# HOSHIZAKI AMERICA, INC.

## SERVICE BULLETIN

**SB94-0010**

**SUBJECT: CHANGE IN WATER SUPPLY SYSTEM**

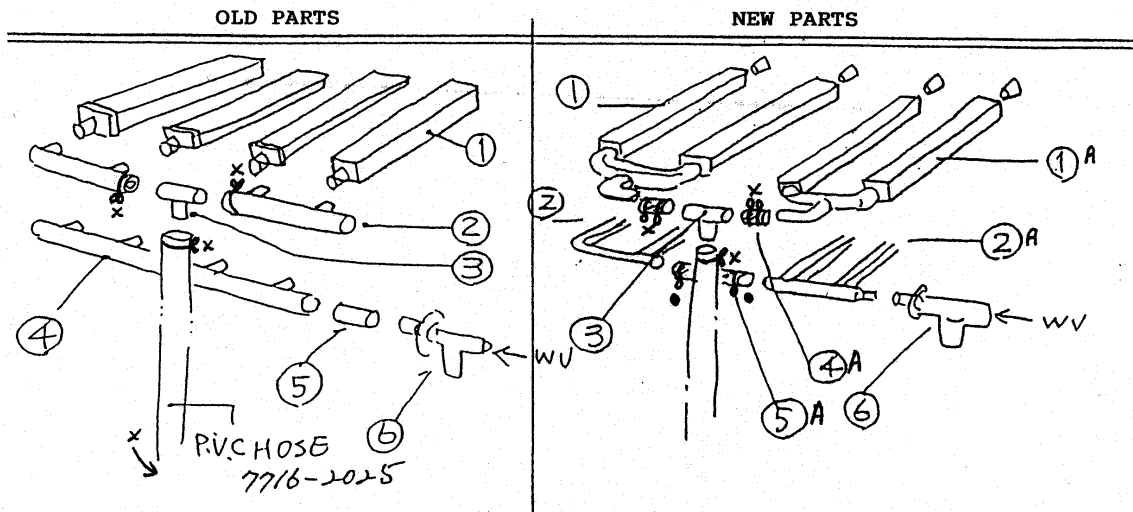
The design change to the water supply system previously introduced on the KM-500/630/800M models (See SB93-0009R) has now been incorporated in the KM-1200/1600M models.

Different parts are needed on these models because of the additional evaporator plates. The new parts are interchangeable as a set only. The old parts will remain available for service replacement, however, you have the ability to change to the new system if desired. To do so, you must order all of the new parts excluding the parts marked same. See chart and drawing on Page 2.

The change is effective beginning the the serial numbers listed below.
